# CHANGE ORDER

OWNER: City of Saratoga Springs, New York  
 CONTRACTOR: Collins Mechanical, LLC  
 Contact: Mark Collins, Owner (518)-466-4115  
 Project: Lake Avenue Fire Station  
 OWNER'S Contract No.: 2012-02 ENGINEER'S Contract No.: 10164-1  
 ENGINEER: Engineered Solutions

**LAKE AVE FIREHOUSE**

**APPARATUS FLOOR REPLACEMENT AND BASEMENT INFILL**

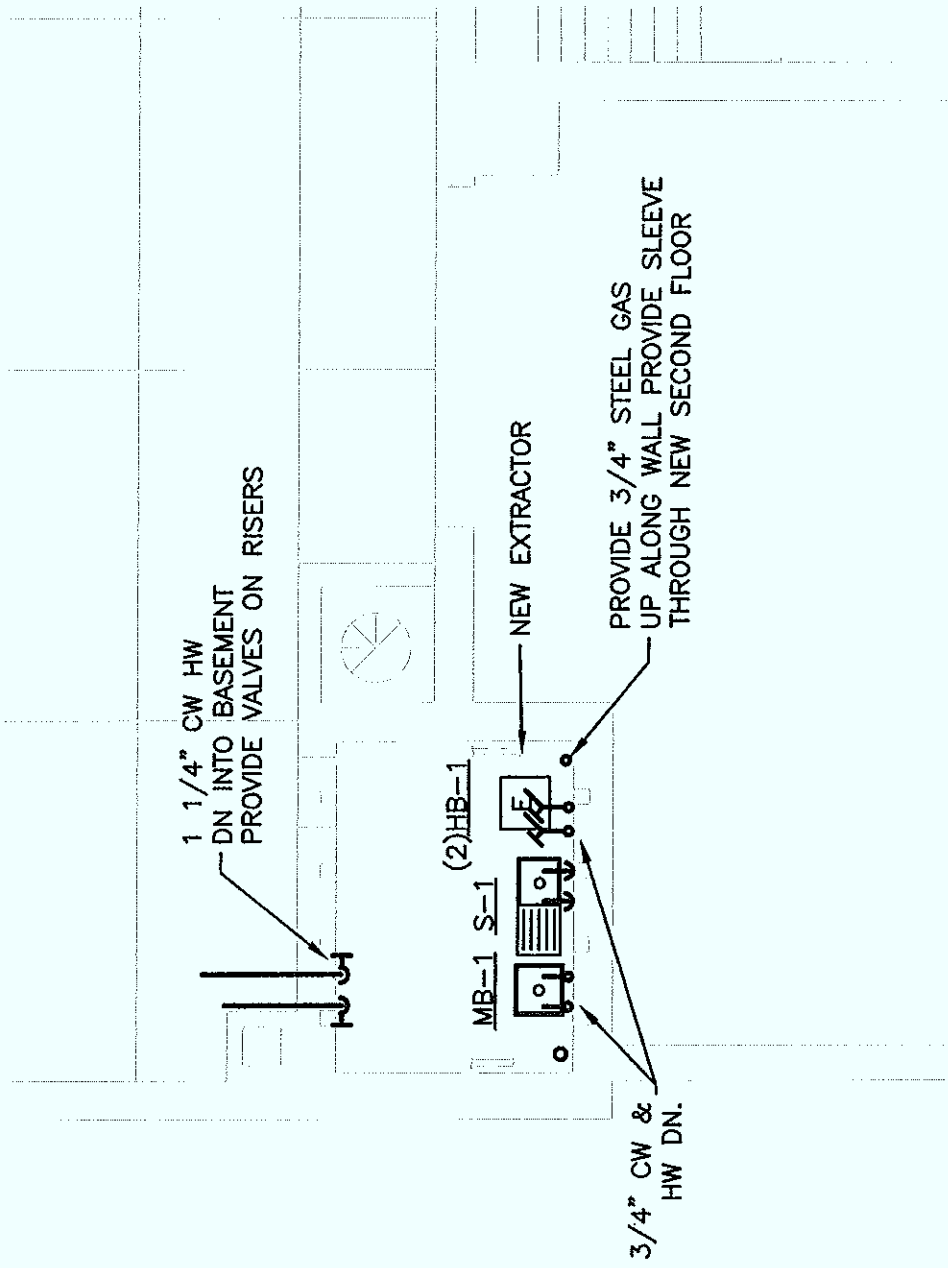
- 1) Please provide a separate **COST** proposal with an itemized breakdown for labor and materials for **each** of the following items:
  - a) Provide pricing for plumbing work indicated and specified on sketches PR PC-001, 002, 003, 004, 005 & 006

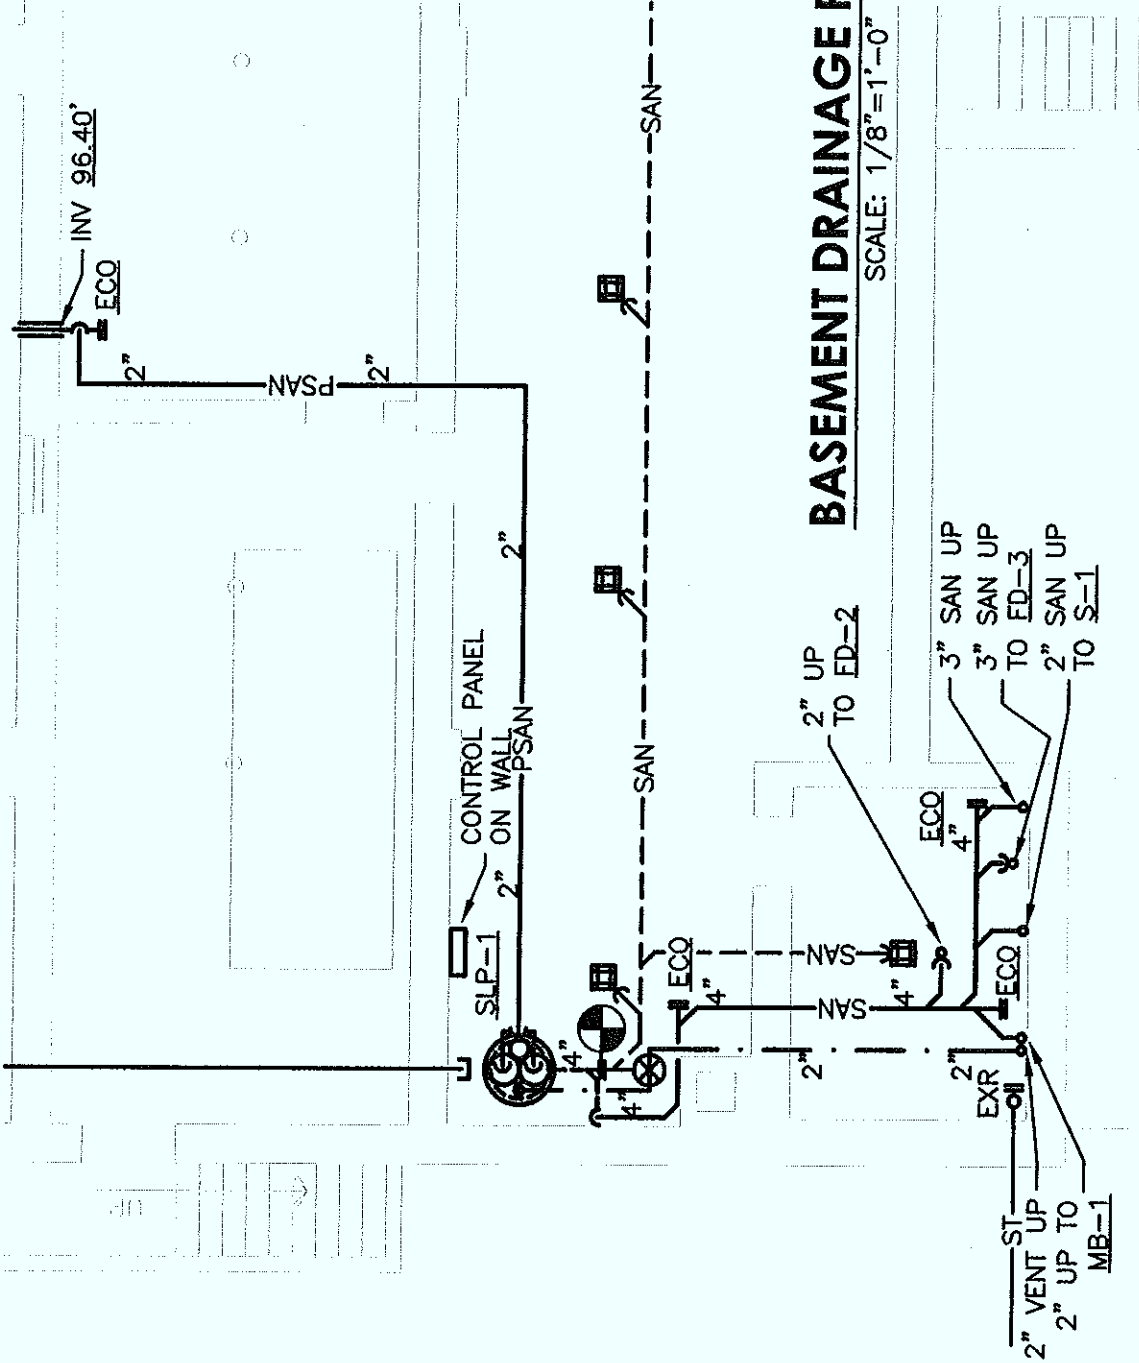
1. SAW CUT FLOOR AND LOCATE EXISTING 4" SAN FROM FLOOR DRAINS.
2. INSTALL NEW SLP-1 IN FLOOR CONNECT NEW DRAINAGE AND BASEMENT FLOOR DRAINS INTO SLP-1
3. EXTEND PUMP DISCHARGE TO POINT INDICATED.
4. SEE SKETCH PR-005 FOR SPECIFICATIONS

- 1.) Install duplex sewage pump system
    - a. Pump System- \$2800.00
    - b. Saw-cut and patch existing basement floor-\$2380.00
    - c. Excavate and set basin and pumps-\$1520.00
  - 2.) Sanitary and vent piping per:  
P004, P005, P006:  
Labor: \$6080.00  
Material:  
    Pipe and fittings-\$3140.00  
    F.D. and CO. F.A. Vent Cover-\$800.00
  - 3.) Hot and Cold Water Piping per:  
P001, P002, P003  
Labor:  
    -- Core decks- \$910.00  
    Hot and cold water piping- \$1520.00  
Material-\$650.00  
Pipe covering-\$850.00
  - 4.) Gas piping:  
Labor- \$1520.00  
Material-\$200.00
  - 5.) Fixtures:  
Ice Machine-\$2375.00  
Two M.B.1- \$4600.00  
One S.1-\$2300.00  
Labor-\$1520.00
- Total: \$33,165.00

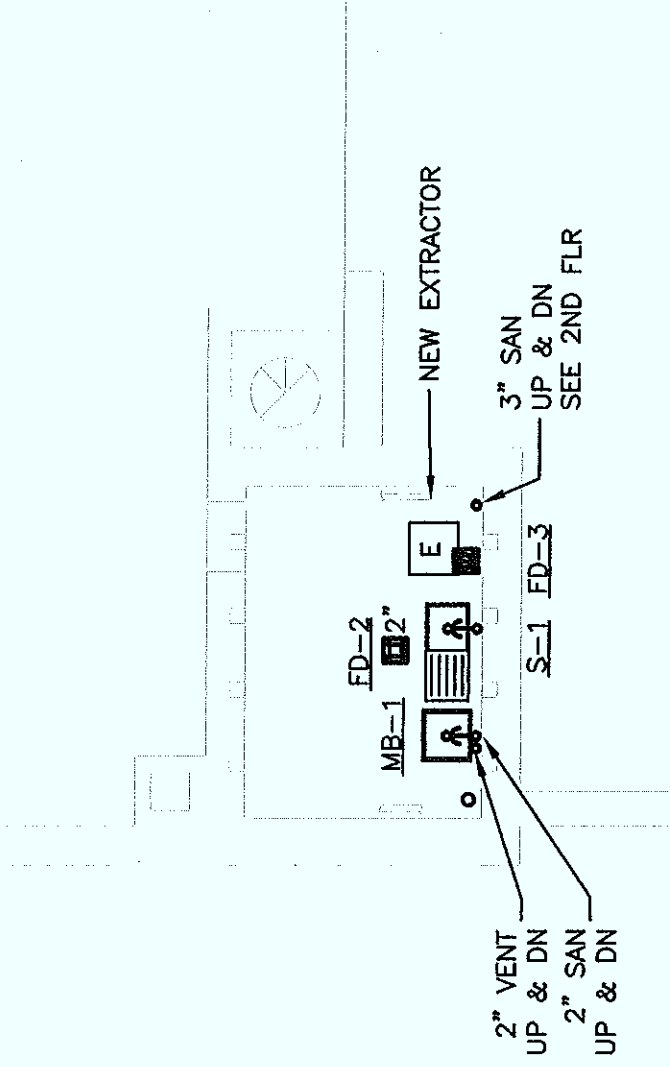
**SLP-1**  
 LIBERTY PUMPS PRE ASSEMBLED DUPLEX SEWAGE SYSTEM 1102/LE51M. 4" INLET 2" DISCHARGE PRE-ASSEMBLED WITH DISCHARGE PUMPS, PIPE, AND FLOATS PRE MOUNTED IN BASIN. BASIN HDPE POLYETHYLENE STRUCTURAL FOAM, 30" X 36" DEEP 110 GALLONS, 4" CAST IRON INLET HUB, COVER HEAVY DUTY 1/4" PLATE STEEL ENAMEL COATED 34" DIA (2) 2" DISCHARGES AND VENT FLANGE. (2) 16" PUMP ACCESS OPENINGS AND ONE 10" INSPECTION COVER, PUMPS SHALL BE LE51M 1/2 HP 115 VOLTS 1PH, 40 GPM @ 15" TDH. CONTROL PANEL AE21L=3 DUPLEX CONTROL PANEL 120 VOLT 1 PH NEMA 1 ENCLOSURE 3 FLOATS 0-14.9 FLA.

**S-1**  
 ADVANCE TABCO # 93-1-24-24L 16 GA 304 SS K-1 8"OC 12" SPOUT FAUCET, K-15 TWIST HANDLE DRAIN W/OVERFLOW, PROVIDE STOPS SUPPLY RSERS AND WASTE OUTLET PIPING INCLUDING 2" P-TRAP.

**MB-1**  
 ADVANCE TABCO # 93-1-24-24L 16 GA 304 SS K-1 8"OC 12" SPOUT FAUCET, K-15 TWIST HANDLE DRAIN W/OVERFLOW, PROVIDE STOPS SUPPLY RSERS AND WASTE OUTLET PIPING INCLUDING 2" P-TRAP.

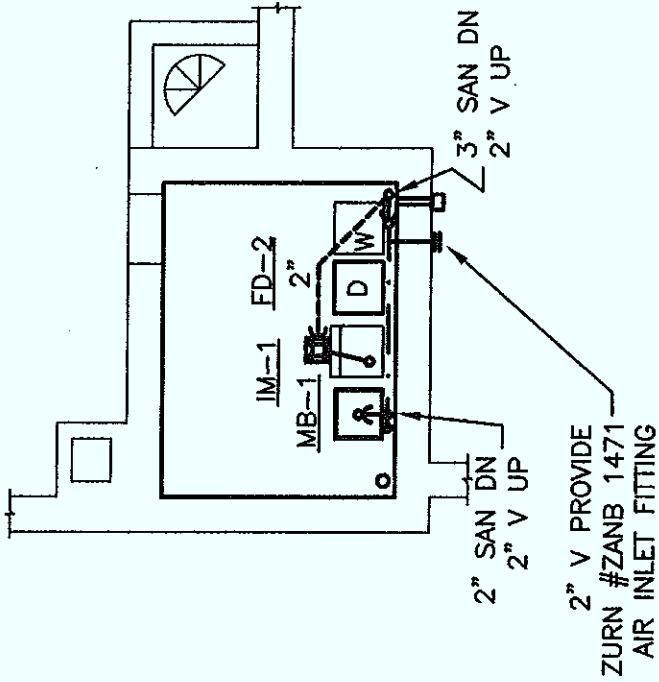
ZURN Z-326 INDIRECT WASTE FUNNEL, 4" DIA DURA COATED CAST IRON BODY AND BOTTOM OUTLET. PROVIDE TRAP ON BASE.

PROVIDE MANITOWOC QD--0132A UNDERCOUNTER ICE MACHINE 135 LB PRODUCTION 80 LB STORAGE. FLOOR MOUNTED PROVIDE WITH 3M CUNO CFS717 WATER FILTER SYSTEM. 120 VOLTS POWER CORD WITH NEAM 5-15P PLUG 7.0 AMPS ENERGY STAR RATED.
